Amendment, Permit # B17000511

Project: Staton  
Building Permit# B17000511  
Address: 513827 Lakeside Drive, Clarksville, MD 21029

These revisions were requested from framing inspection:

**1**  
 A2.0 PROPOSED BASEMENT PLAN  
 1/4" = 1'-0"

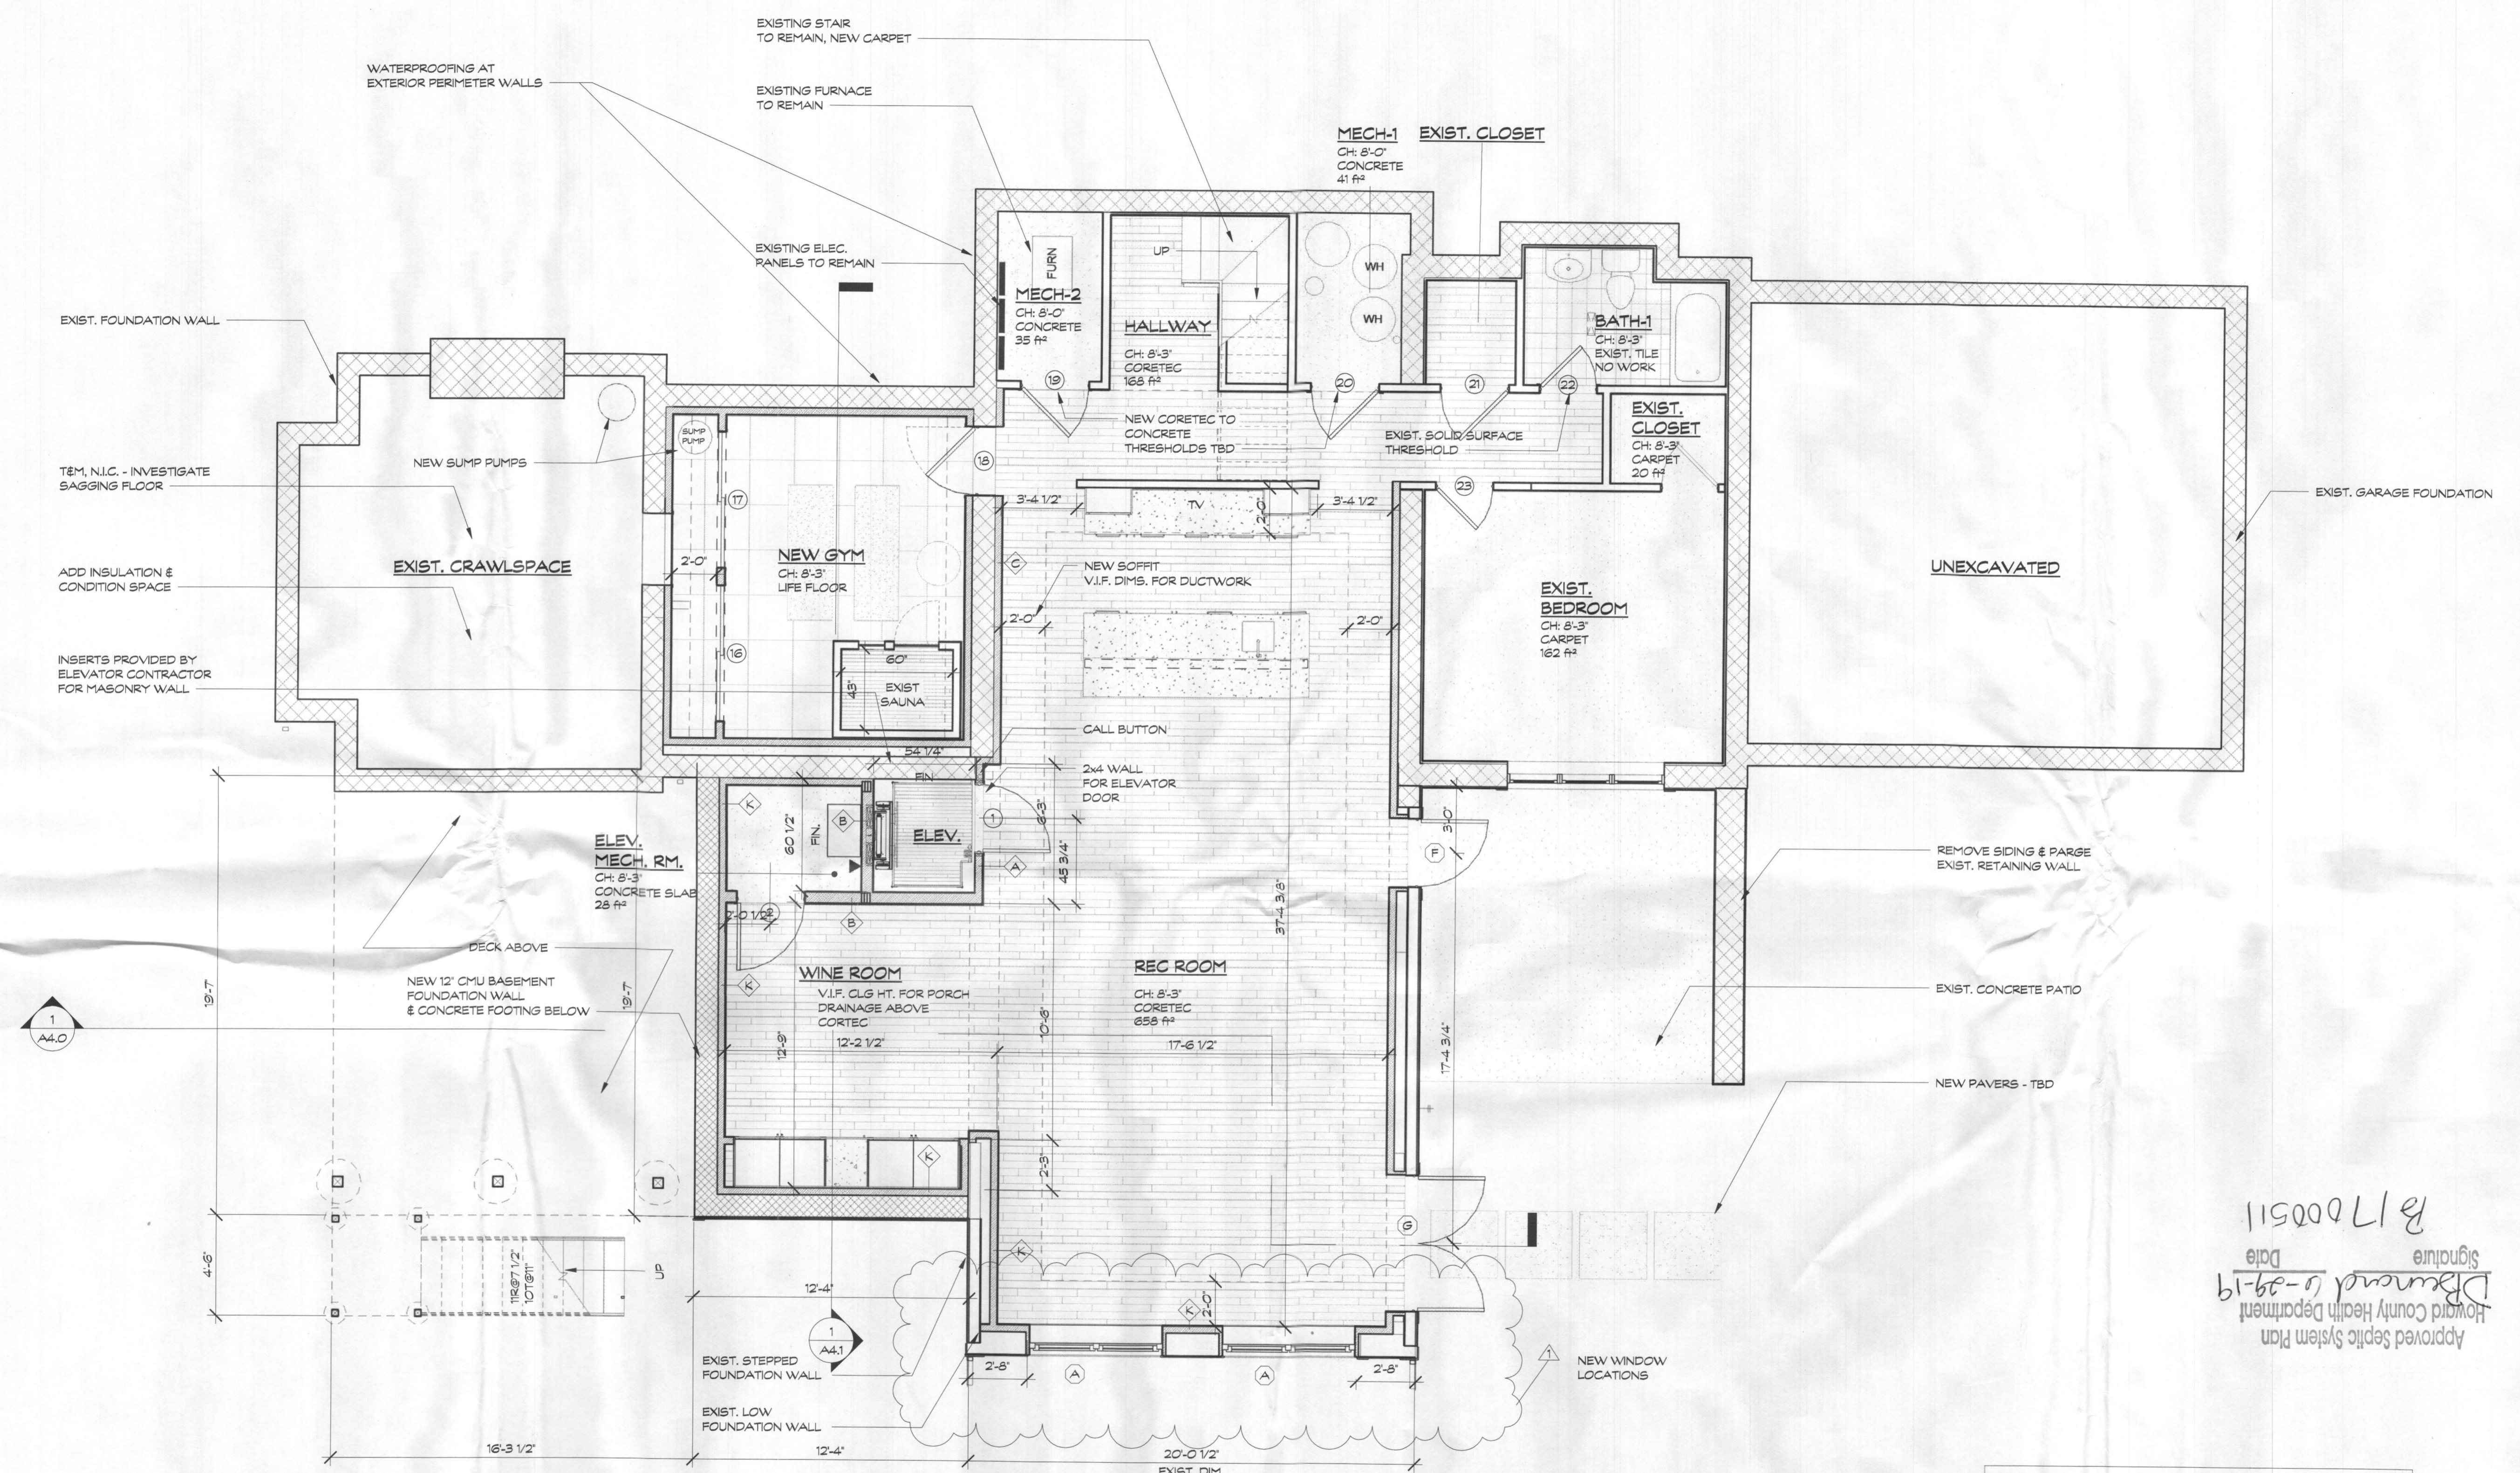
1. New window configuration on 1st floor rear wall, Living room Area. And, re-centering basement and 2<sup>nd</sup> floor windows accordingly.
2. Added new double casement window on 1<sup>st</sup> floor, Living Room Area.
3. Added new double casement window on 2<sup>nd</sup> floor, Master Bedroom.
4. Replaced 1<sup>st</sup> floor Laundry Room window.
5. New location of Screened Porch door opening and posts.
6. Deleted 2<sup>nd</sup> Floor Master Closet Windows.
7. Replaced rotting wood framing on front Entry Foyer wall.

sheet title:  
**Proposed  
First Floor  
Plan**

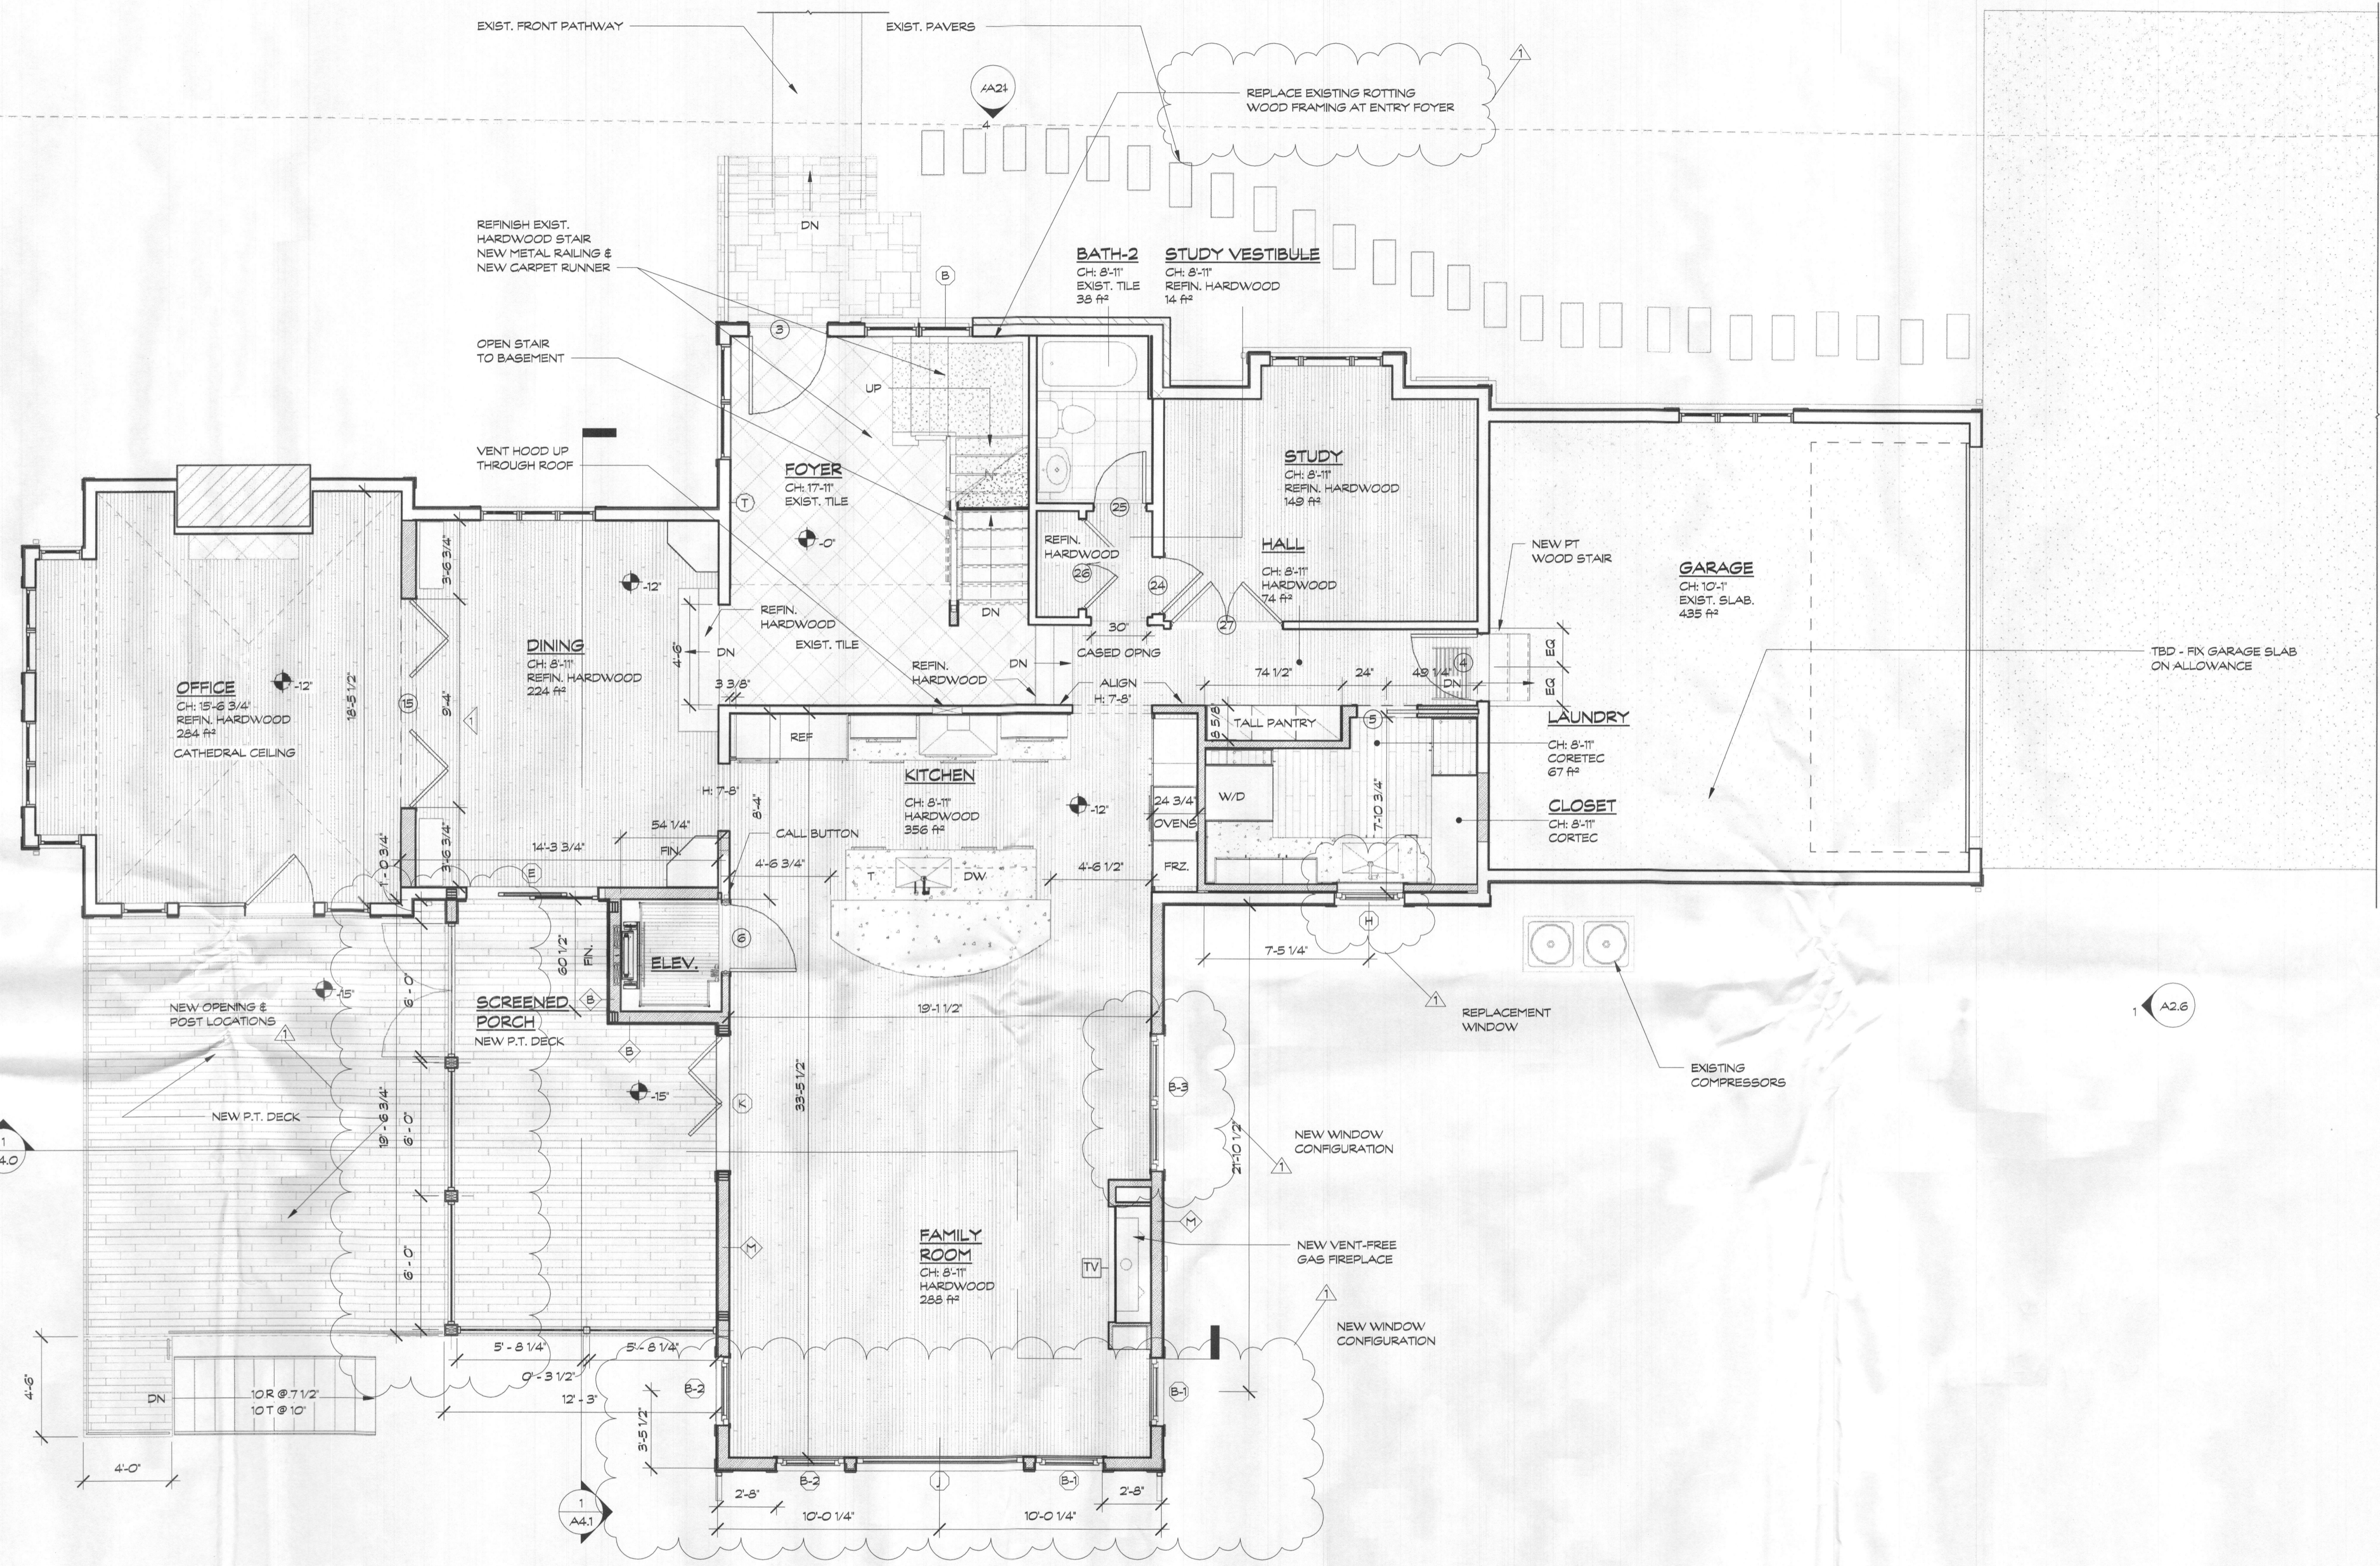
REPLACE EXISTING ROTTING  
WOOD FRAMING AT ENTRY FOYER

NEW WINDOW CONFIGURATION

NEW WINDOW CONFIGURATION
